[Docket No. 2000-SW-33-AD; Amendment 39-11881; AD 2000-17-07]

Airworthiness Directives; Eurocopter France Model EC120B Helicopters

ACTION: Final rule; request for comments.

Figure 1

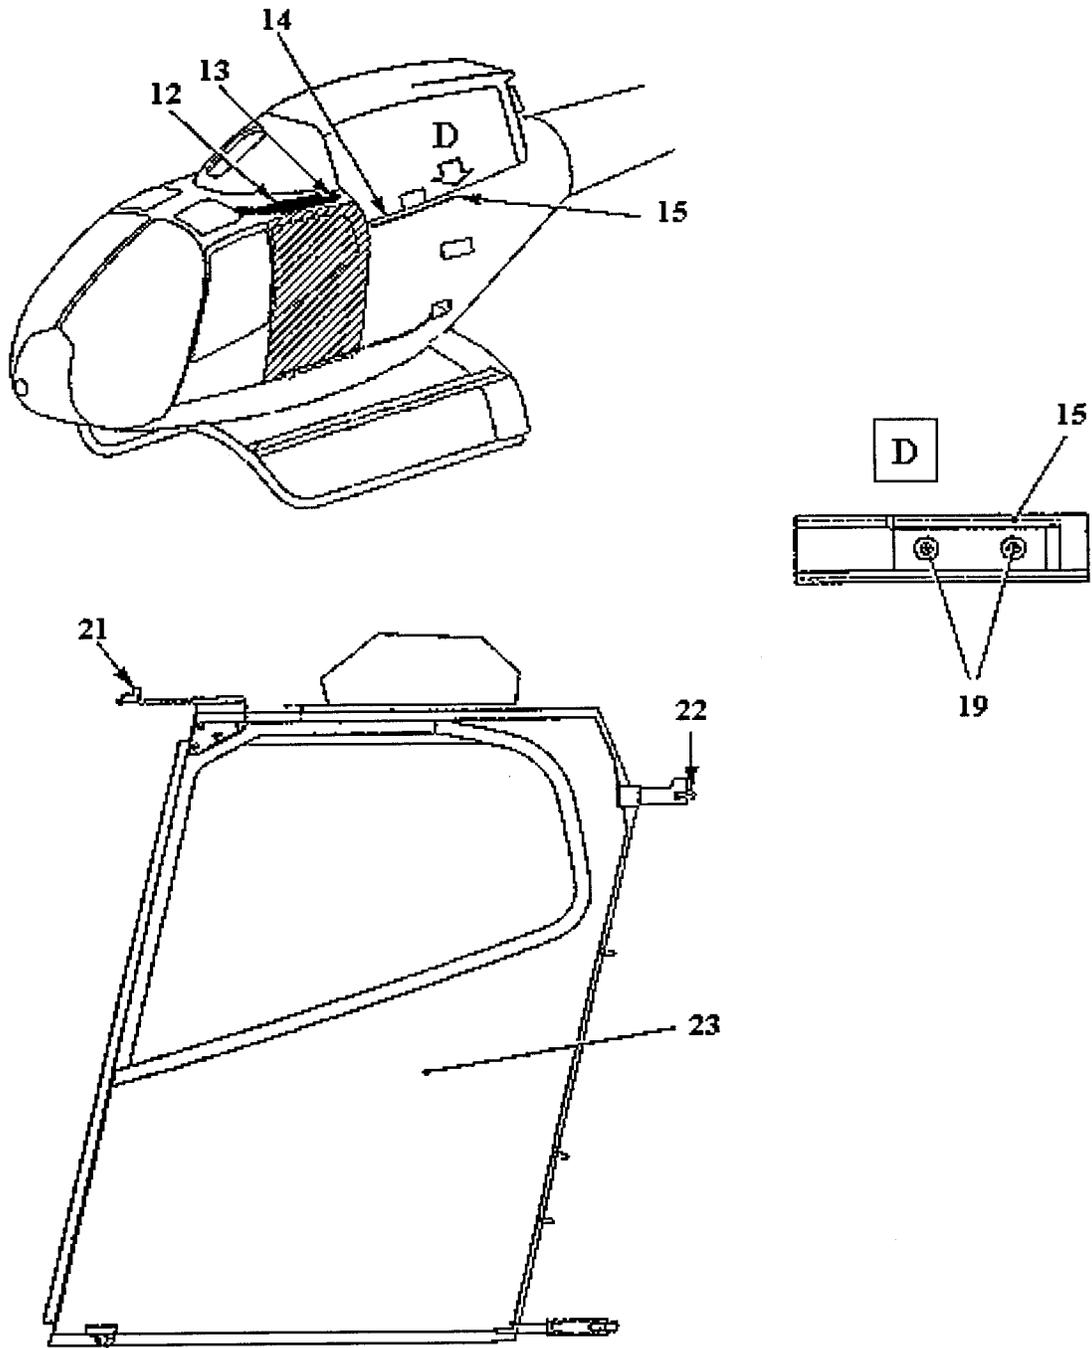
(a) Adjust the cabin sliding door (23) (see Figure 1) in accordance with the following:

(1) Loosen the screws (19) and the stop (15).

(2) Open and push the cabin sliding door aft until the roller goes past the locking pin (13) while keeping the roller (21) inside the rail (12).

(3) Move the cabin sliding door forward to bring the roller (21) into contact with the locking pin (13).

(4) Move the stop (15) as far forward as possible toward the nose of the aircraft.

(5) Mark the location of the stop (15) with respect to the rail (14).

(6) Unlock the cabin sliding door and move it forward to gain access to the screws (19).

(7) Hold the stop (15) aligned with the rail (14), and secure the stop (15) and the screws (19) at the location previously marked.

(8) Ensure that the pin (13) locking mechanism (pin) locks the cabin sliding door in the open position. If the pin does not lock the door in the open position, before further flight, repair or replace the pin with an airworthy pin.

(9) Bring the roller (22) into contact with the stop (15) of the rail (14).

(10) If the roller (21) is completely inside the rail (12) with a minimum clearance of 3 mm from the aft end of the rail (12), the cabin door is properly adjusted and no further action is required by this AD.

(11) If the roller (21) is less than 3 mm from the aft end of the rail (12), before further flight, repeat steps (1) through (10) until a minimum clearance of 3 mm is obtained.
